Subject: working draft SCSI-3 Controller Commands

T10 Project 1365D

Revision ~~0~~1
~~2805-May~~Oct-2000

Information technology - SCSI Parallel Interface-4 (SPI-4)

Figure 50 - LVD timing measurement points for DT data transfers (paced transfers enabled)

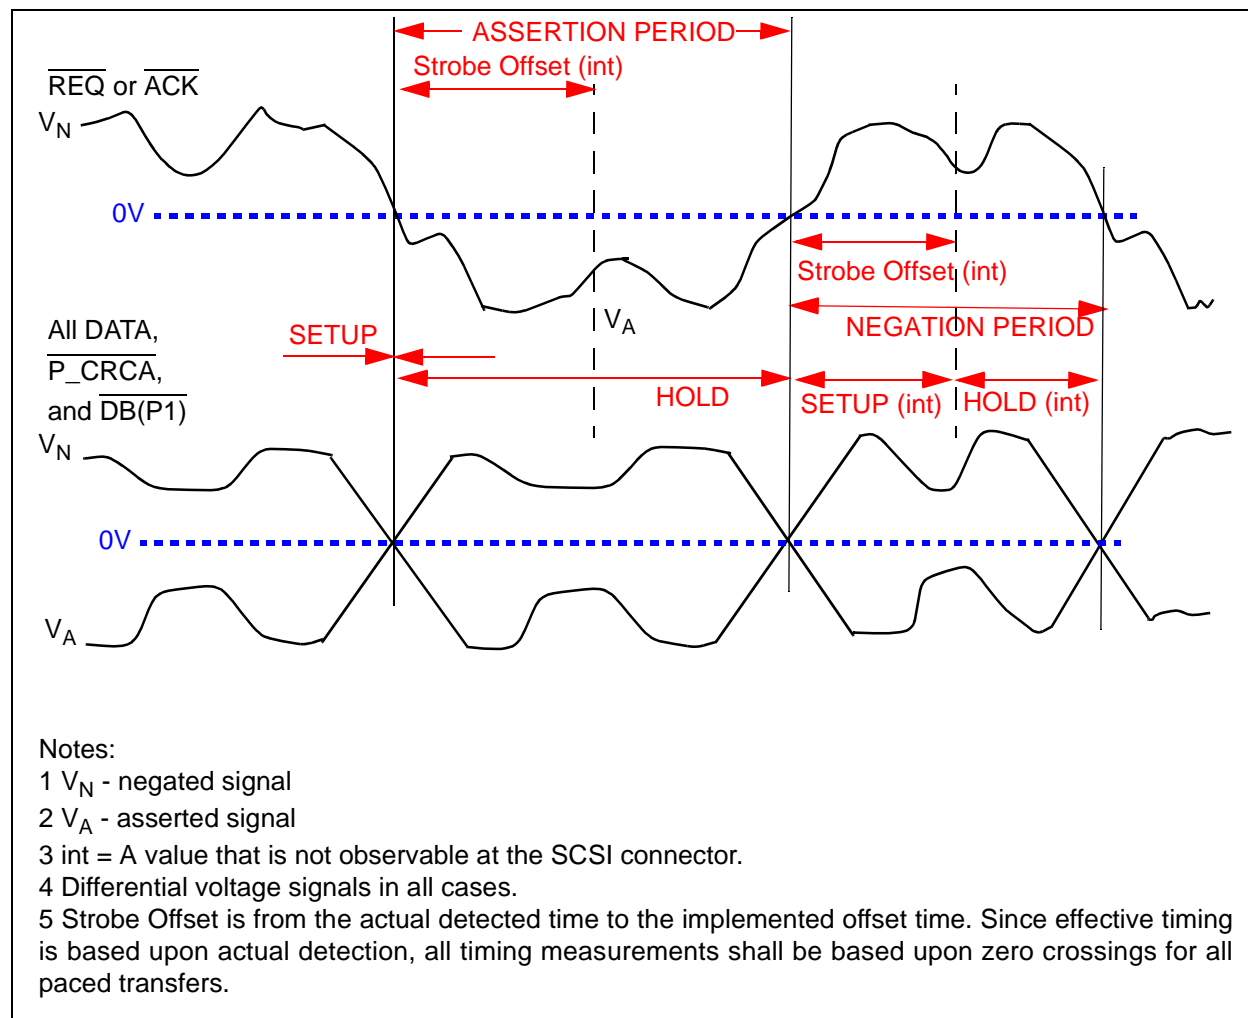
Driver timing parameters applied at the connector of the transmitting SCSI device are defined in figure 48, figure 49, and figure 50. The driver timing parameters shall be measured using the circuit and test conditions defined in A.2.6. Receiver timing parameters applied at the connector of the receiving SCSI device are defined in figure 48 and figure 49. The receiver timing parameters include the effects of arbitrary data patterns and REQ/ACK pauses.

Figure 52 - LVD receiver mask ~~4~~for noncompensated isolated negation pulse (paced transfers)

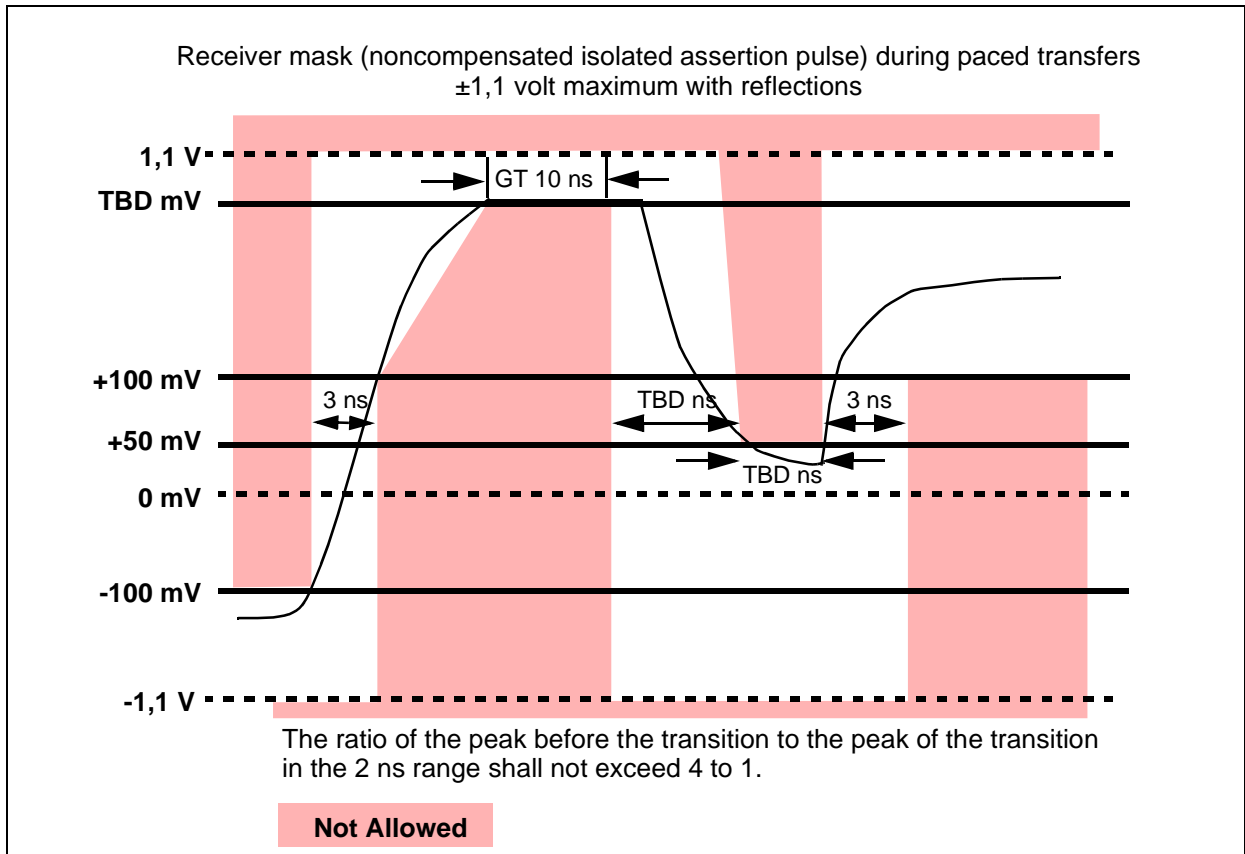
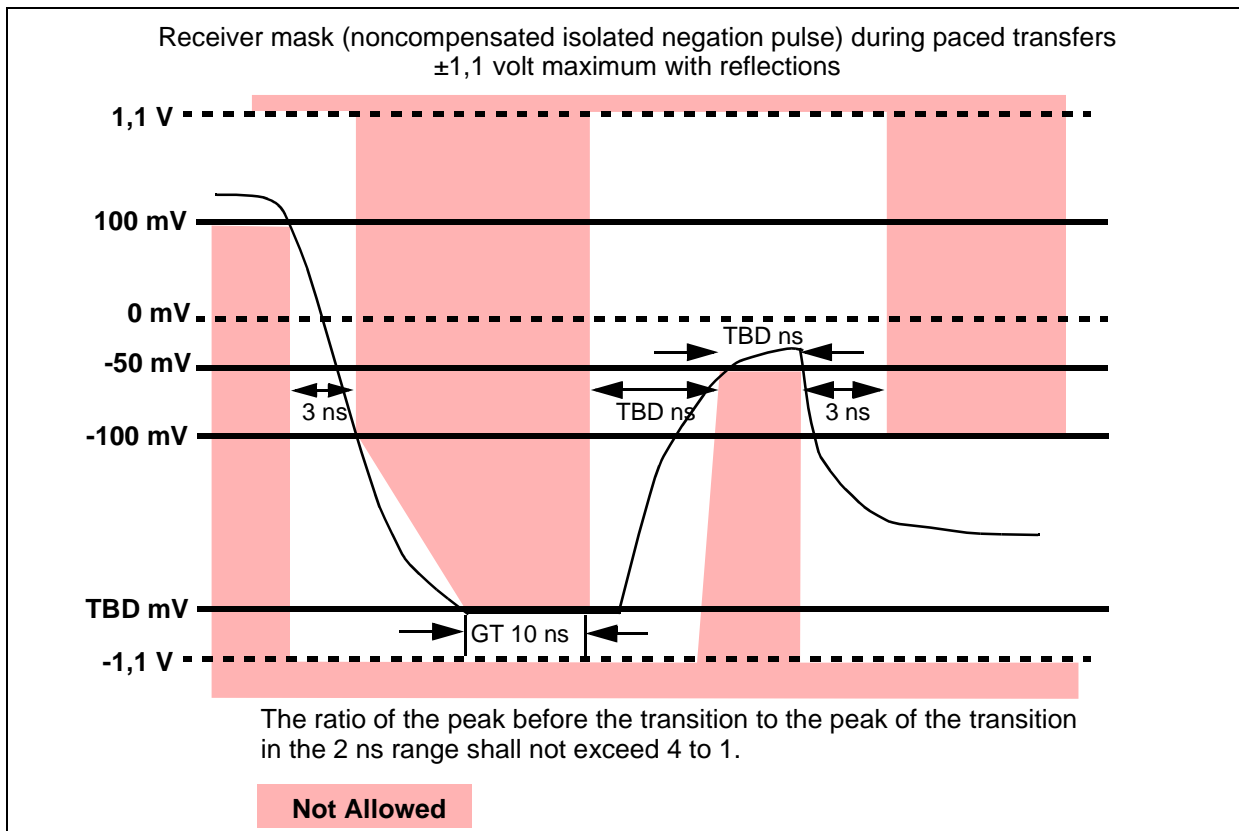
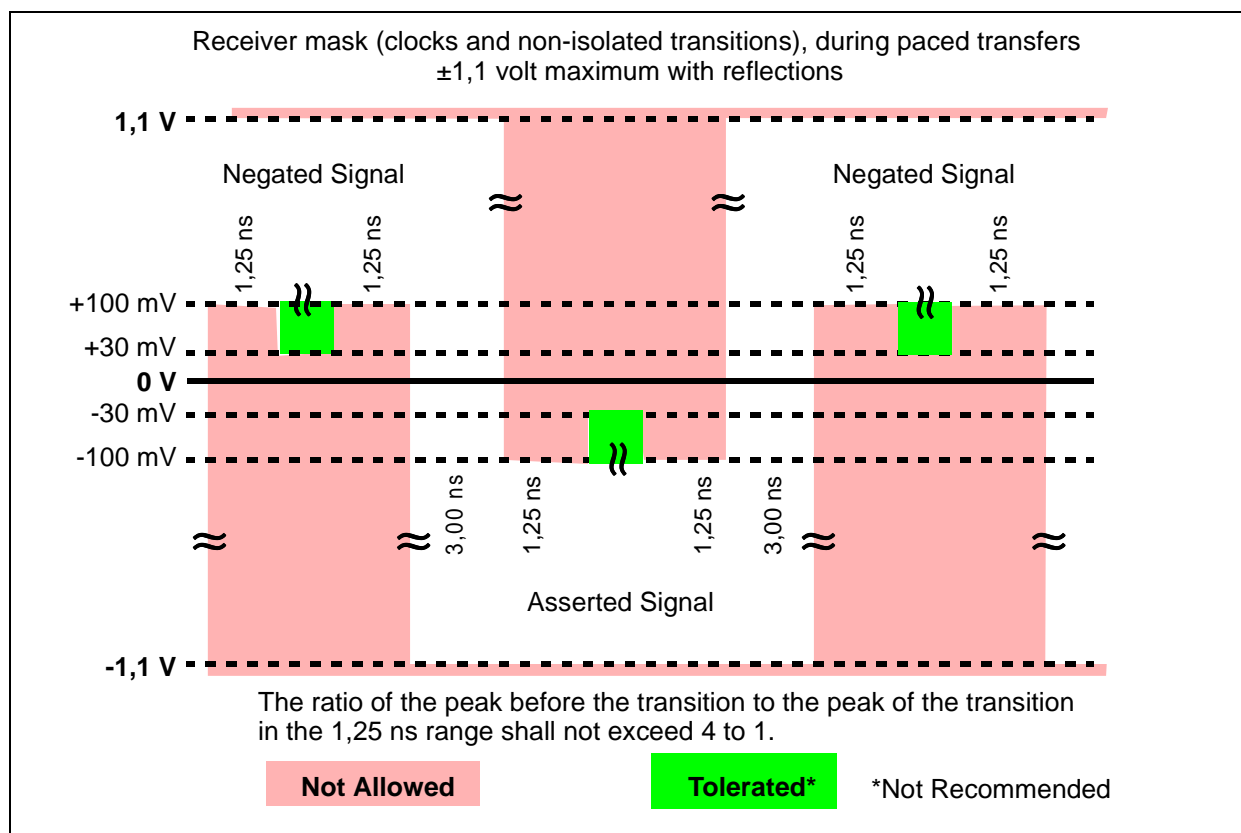
[During paced transfers noncompensated data signals shall operate with signals at the receiving SCSI device meeting figure 52, figure 53, and figure 54.](#)

Editors Note 3 - GOP: There needs to be figure added to show the minimum mask when precomp is ~~disabled~~ [enabled](#).

Figure 58 - ~~System~~ Receiver internal setup and hold timings for fast-160 DT data ~~transfers (paced transfers)~~

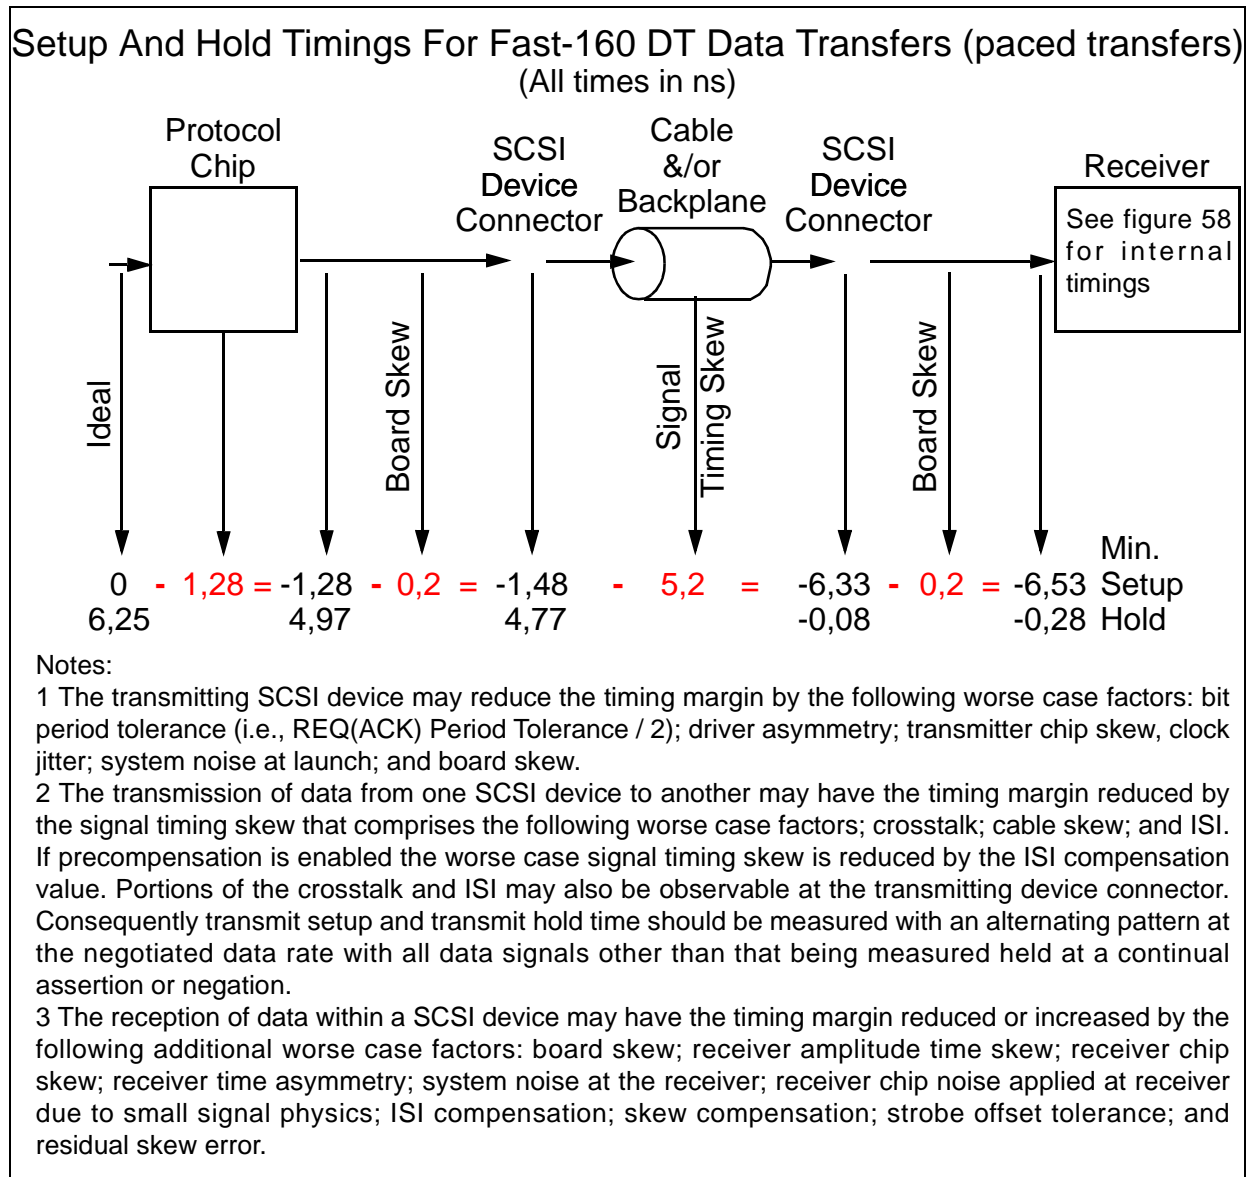
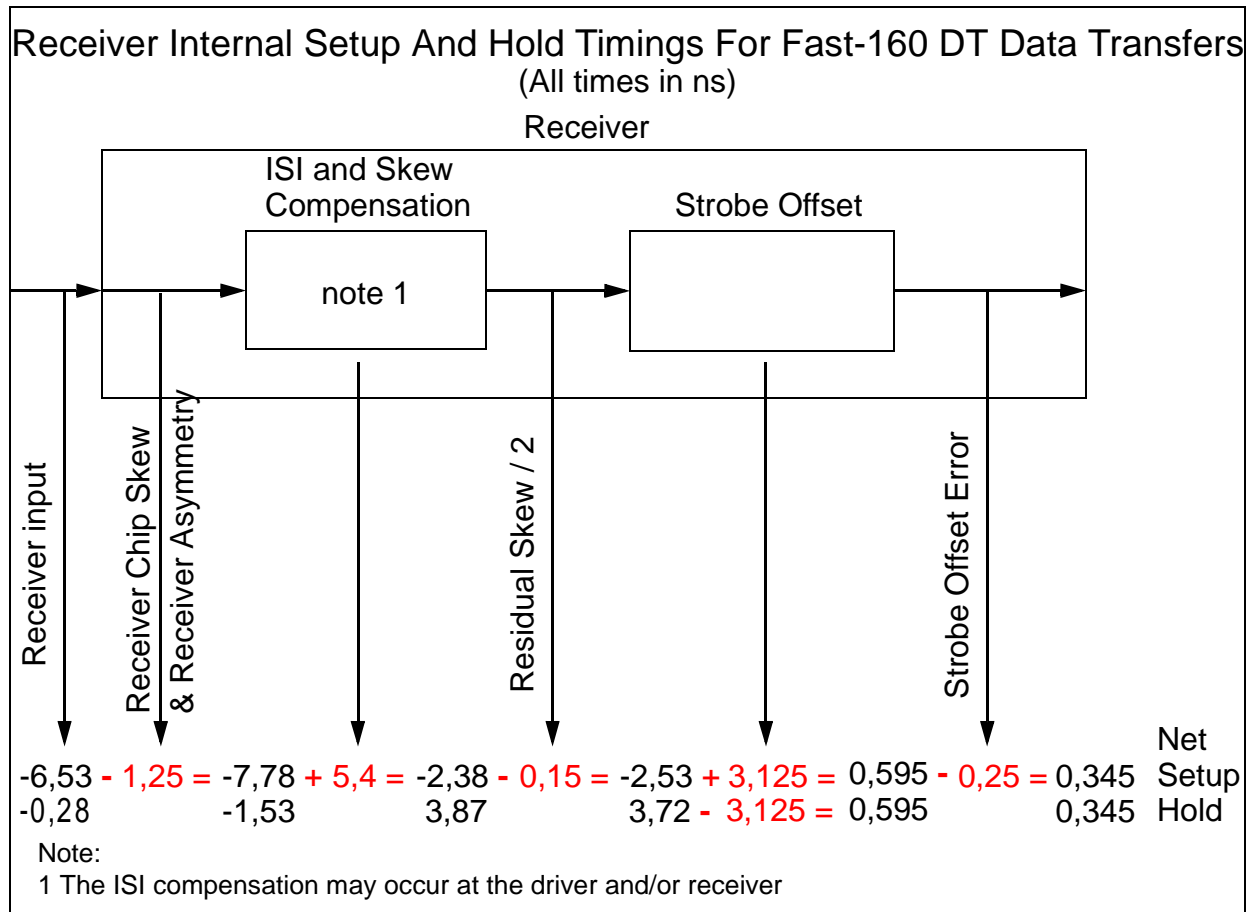
Figure 56 shows how the setup and hold times are calculated for various physical configurations [using synchronous transfers](#) on SCSI devices that support DT data [transfers](#). [Figure 57 and figure 58 show how the setup and hold times are calculated for various physical configurations using paced transfers](#). The minimum set up and hold timings specified in [figure 56, figure 57, and figure 58](#) shall be used. Note that these values are different for the driver and the receiver but that the receiver sensitivity provides the threshold points for both. This is required because both extreme cases of attenuation need to be covered:

Figure A.3 - Domain for driver assertion and negation ~~levels~~[levels for paced transfers](#)

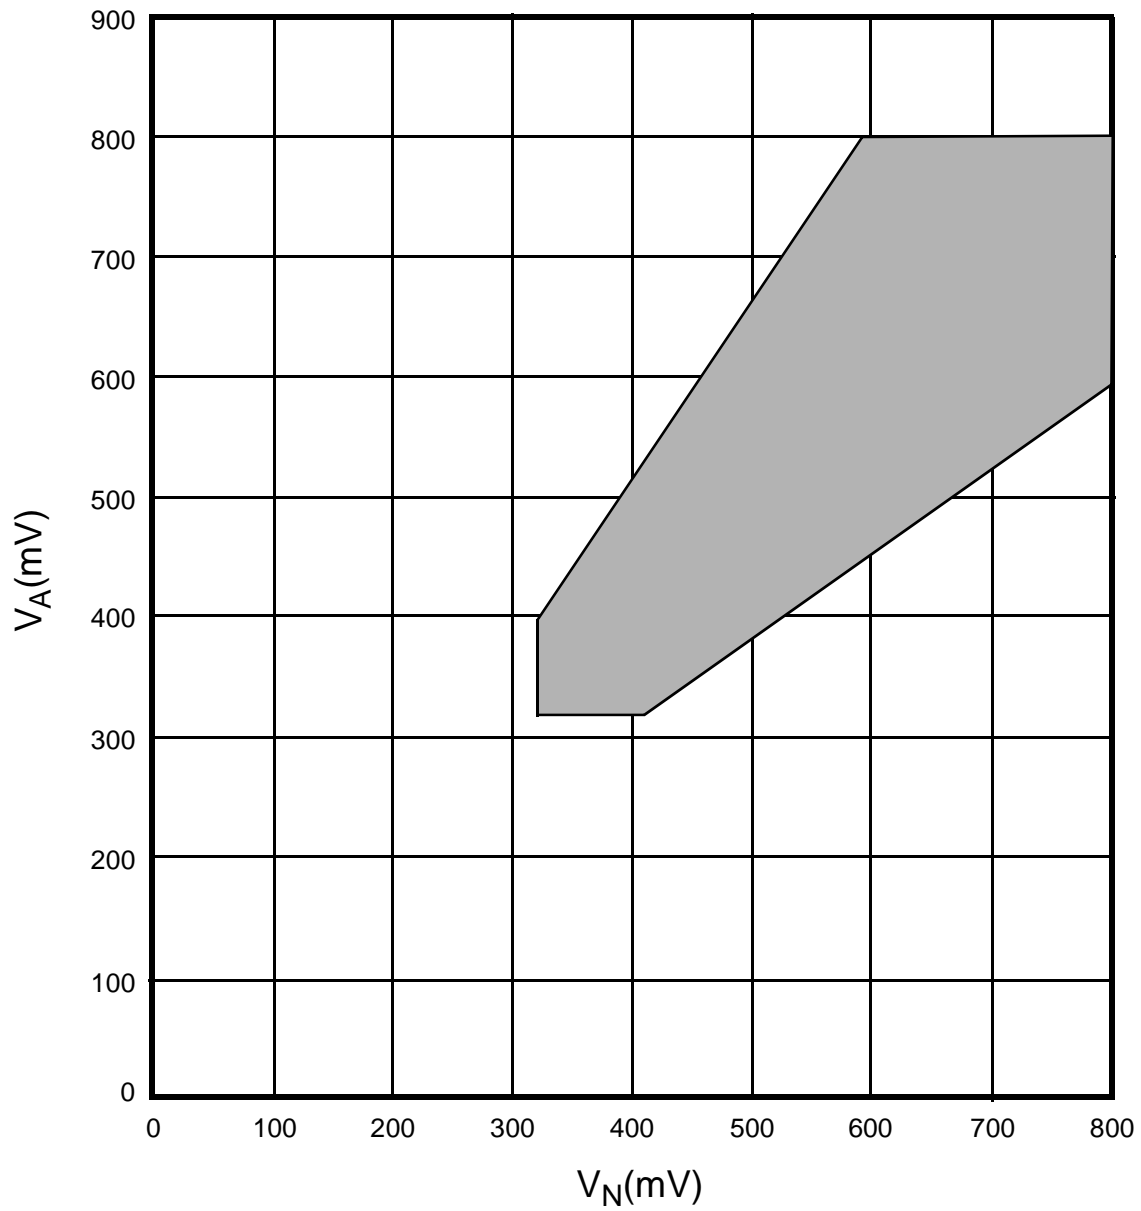
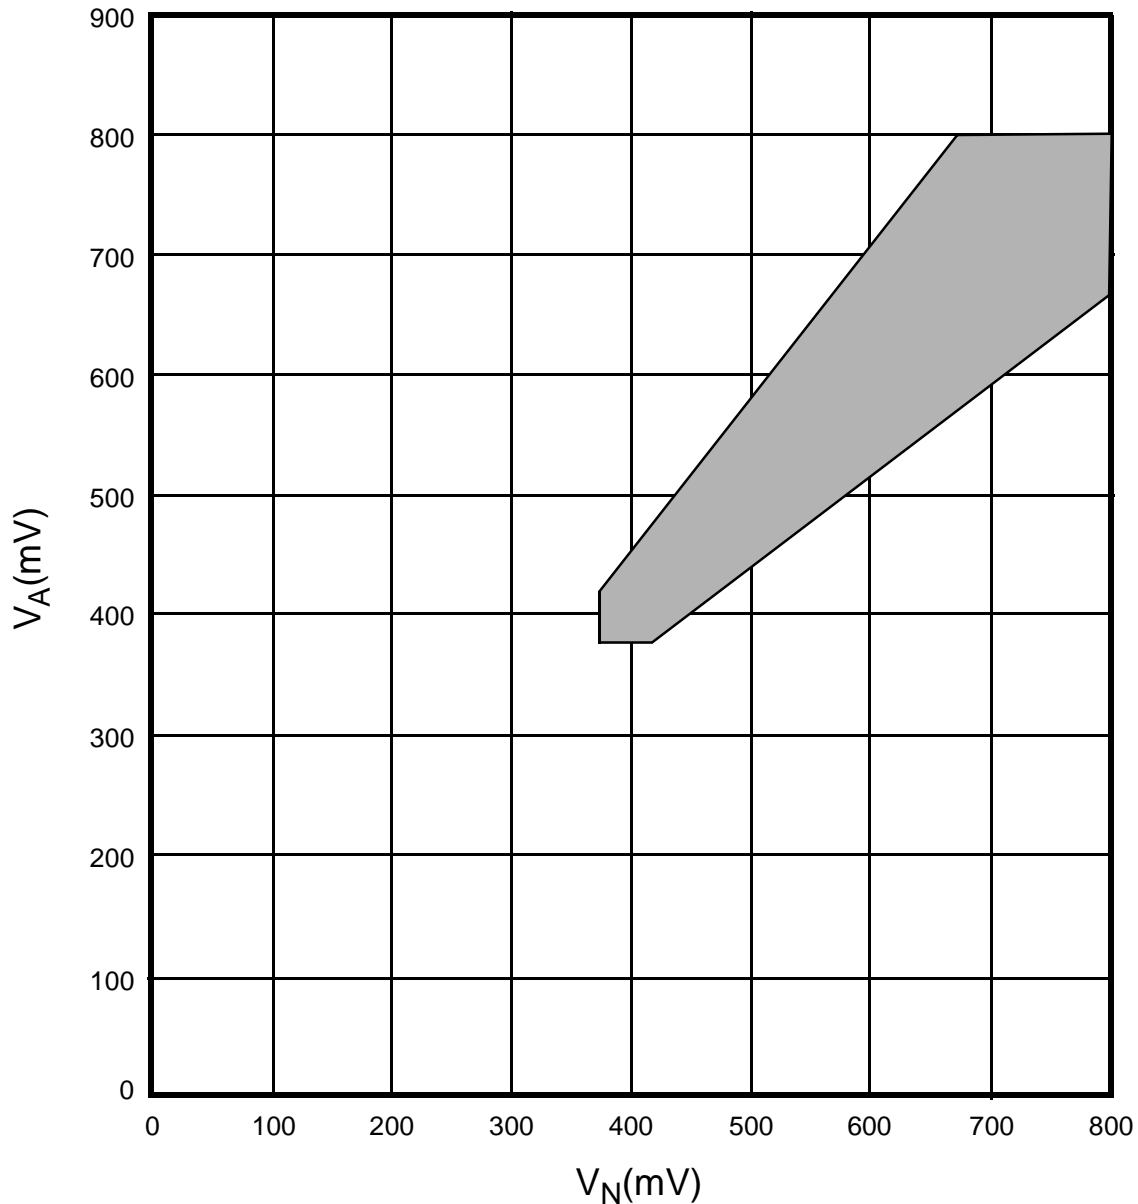
For paced transfers, with the test circuit of figure A.1 and the test conditions V1 and V2 in table A.3 applied, the steady-state magnitude of the differential output voltage, V_S , for an asserted state (V_A), shall be greater than or equal to 370 mV and less than or equal to 800 mV. For the negated state, the polarity of V_S shall be reversed (V_N) and the differential voltage magnitude shall be greater than or equal to 370 mV and less than or equal to 800 mV. The relationship between V_A and V_N specified in table A.3 and shown graphically in figure A.3 shall be maintained. If precompensation is enabled the signal level for the strong driver shall be capable of greater than or equal to 500 mV and shall be less than or equal to 800 mV in the V_N and V_A states. The strong driver relationship between V_A and V_N specified in table A.2 strong driver and shown graphically in figure A.3 for the strong shall be maintained.

The assertion drivers and negation drivers require different strengths to achieve the near equality in V_A and V_N shown in figure A.2 and figure A.3 because the applied V1 and V2 simulate the effects of the bus termination bias.
